**Port Stephens
Local Traffic Committee Minutes**

**Meeting held in the Port Stephens Council Committee room and via Zoom on
Tuesday 3rd October 2023, at 9:30am**

Ferodale Road, Medowie – Formalisation of bus stop ID: 2318238

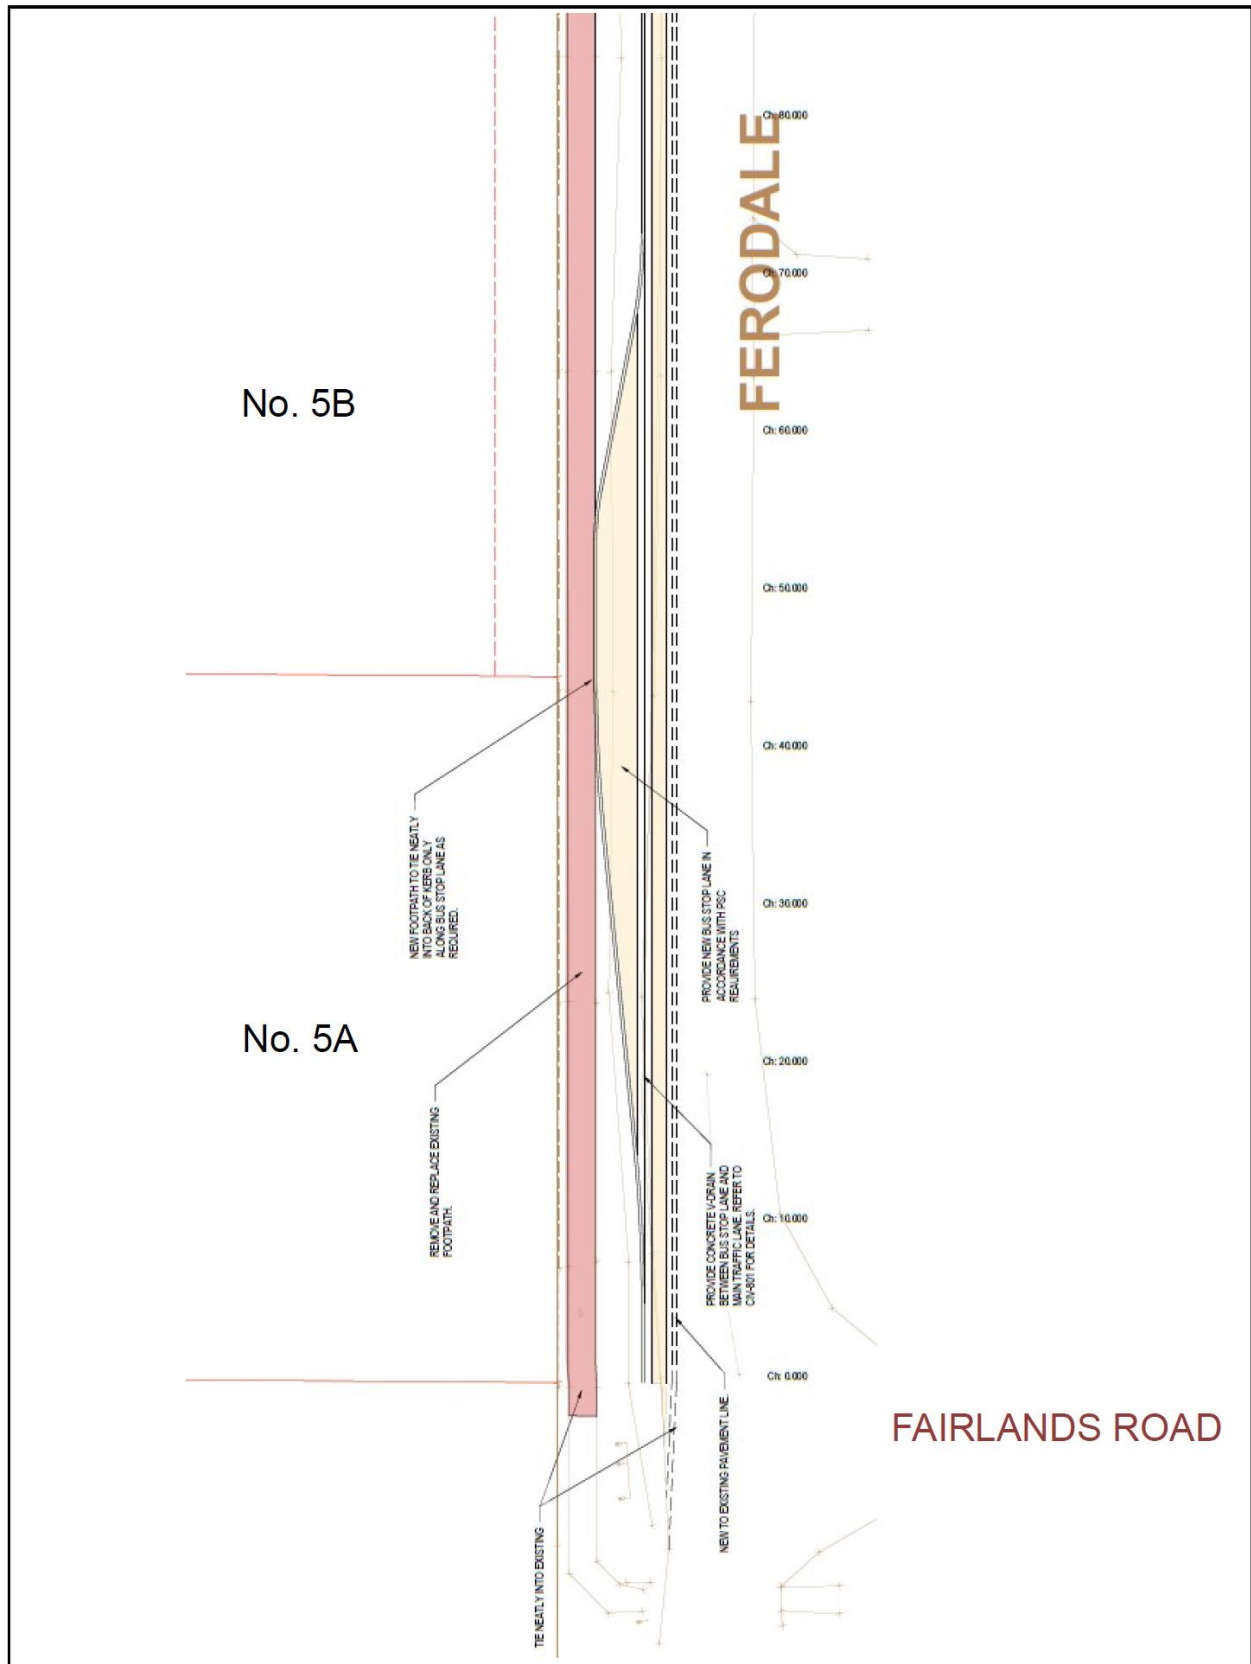
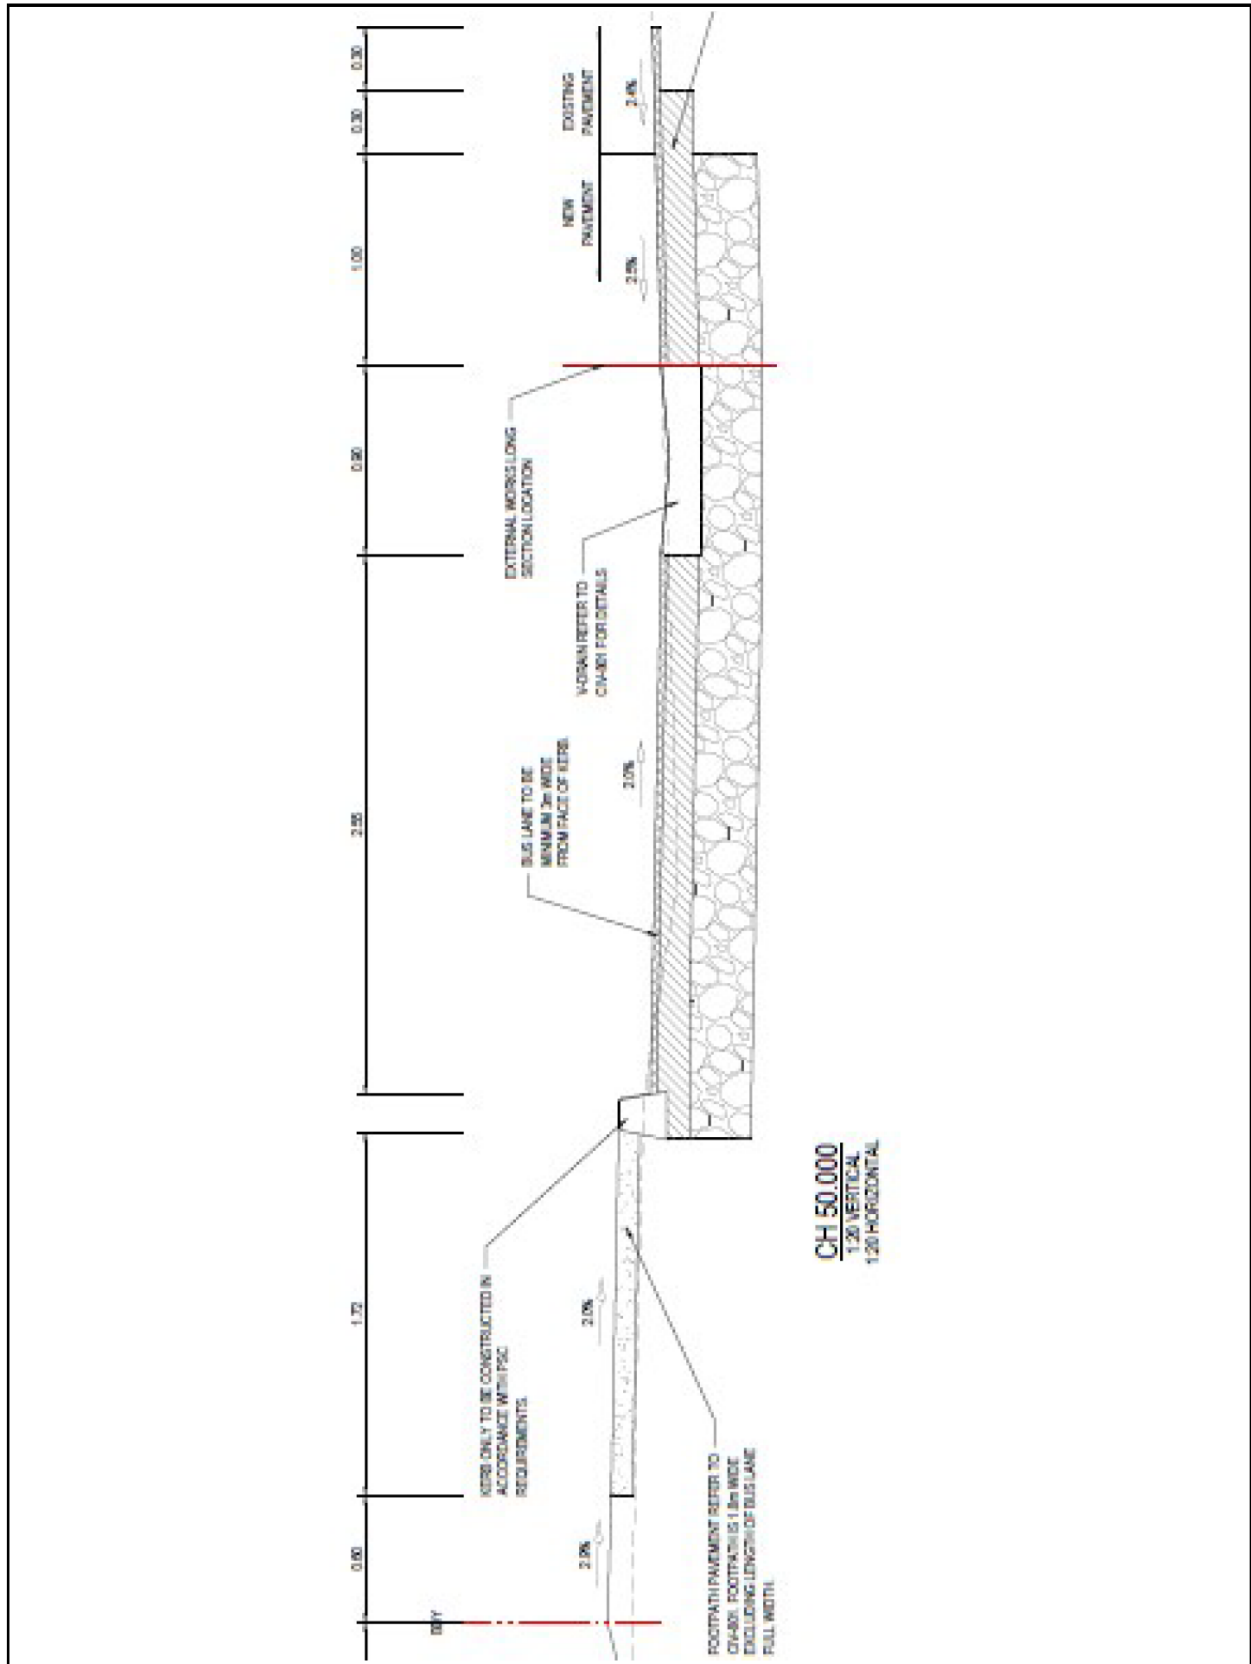
Google maps shows the bus stop on the northern side of Ferodale Road, just after Fairlands Road but there is no infrastructure in evidence.

Local Traffic Committee members noted that it will be difficult to fit a DDA compliant bus stop, at the location indicated, but that the general concept of the bus stop is supported by the Traffic Committee. It was noted that Council's Development Engineers will be able to liaise with the developer to ensure that a suitable outcome is achieved for the community.

Endorse the bus stop design plan, as shown on the attached sketch, Annexure A.
